AMENDMENT TO BUILDING PERMIT #2014-01378 87 Devon St., Portland, ME 04102

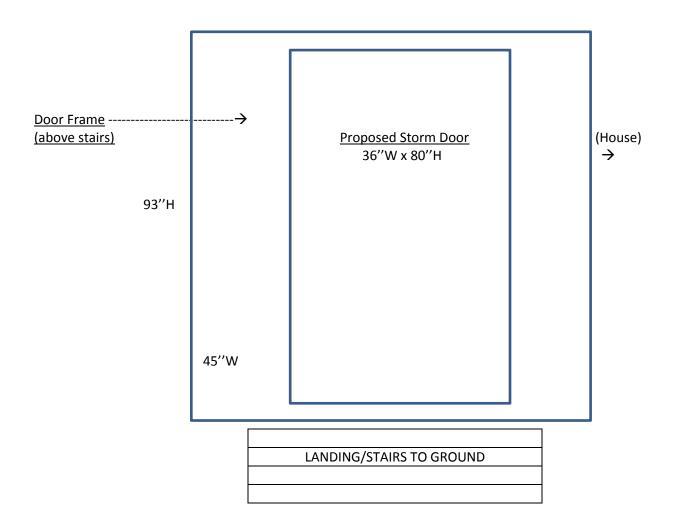
^{**}Remove headers and construct new 2x6 double header. Frame in wall as necessary, use external PVC trim & vinyl siding to match existing house.

^{*}Two vinyl windows above proposed stairs to be removed and replaced with one 36"w x 80 h", aluminum (outswing) storm door.
